# Nº 124 SERVICE BULLETIN

SUBJ: Software Update: Replay Bug Fix for

Sharkeys Shootout & High Roller Casino

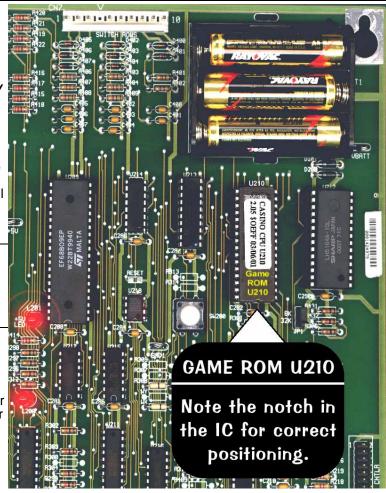
When replacing ROMs, use a proper flat tool to carefully remove the ROM. Make sure you are prying up the ROM AND NOT the IC SOCKET!!! When inserting the replacement ROM, ensure the Pins do not bend while inserting into the IC Socket. Note the position of the NOTCH. It should be in the same position as all the other ICs on the CPU Sound Board. U210 is located just under the batteries (Upper Right Corner) on your CPU/Sound Board, in the Backbox.

Update your game with the latest revision of software. For Sharkey's Shootout, Game **ROM U210**, **v2.06**, is required. For High Roller Casino, Game **ROM U210**, **v2.05**, is required.
